Work Order ID 84540

Item Name: 205 Skidtube bent detail

DRAWING NO. D2580	TITLE 205 SKIDTUBE ASSEMBLY	REV. E	DART AEROSPACE LTD ENGINEERING ORDER	D.E.O. NO. D2580-E-1	SHEET NO. SHEET 1 OF 1	SCALE NTS
DRAWN <i>UP</i>	CHECKED <i>ASS</i>	MFG. APPR. <i>ER</i>	APPROVED <i>#</i>	DE APPR. <i>#</i>		
DATE 11.12.13	DATE 11.12.13	DATE 11.12.13	DATE 11.12.13	DATE 11.12.13

CHANGE ALL C'BORED WELDED CROSSBOLT SPACERS TO SWAGED SPACERS

DETAIL G 03-5
SCALE 5X

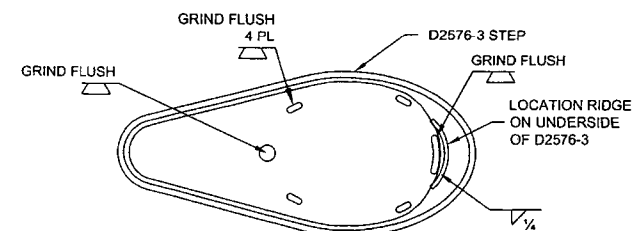
- AFTER DRILLING AND BENDING ASSEMBLY
PERFORM THE FOLLOWING FOR Ø0.508 HOLES ONLY:**
- 1. CHAMFER HOLE 0.050 X 45°**
 - 2. INSERT D2579 SPACER (24 PLACES)**
 - 3. WELD INTO PLACE AND GRIND FLUSH**
 - 4. C'BORE D2579 SPACER TO Ø0.437 X 1.00 DEEP**

SECTION B-B, F-F, I-I
NOT TO SCALE

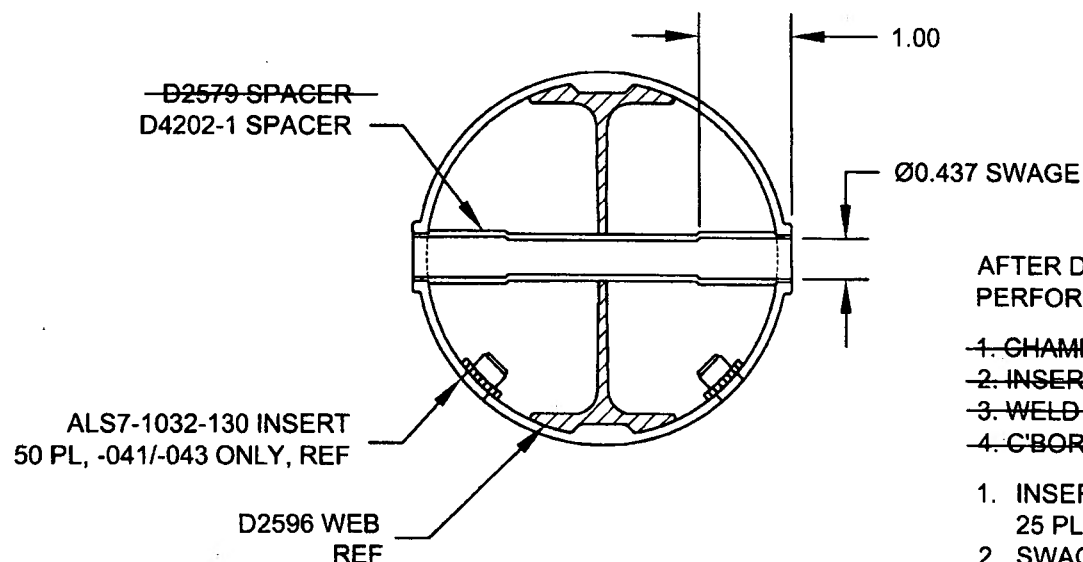
SECTION B-B, SECTION F-F, & SECTION I-I ARE AMENDED AS FOLLOWS
FOR ALL HOLES THAT WERE ORIGINALLY C'BORED:

- ~~1. CHAMFER HOLE 0.050 X 45°~~
- ~~2. INSERT D2579 SPACER (20 PLACES)~~
- ~~3. WELD INTO PLACE AND GRIND FLUSH~~
- ~~4. C'BORE D2579 SPACER TO Ø0.437 X 1.00 DEEP~~

*** FOR -045 SKIDTUBE ONLY:**
WELD 4X D2579 SPACERS PER DWG
IN LOCATIONS MARKED "NO C'BORE".
REF SHEET 4 OF DWG.

1. INSERT D4202-1 SPACER, 20 PL (-041) OR 20 PL (-045) OR 25 PL (-047)
2. SWAGE TO Ø0.437 X 1.00 DEEP PER QSI 002
3. TRIM / GRIND FLUSH PER QSI 002
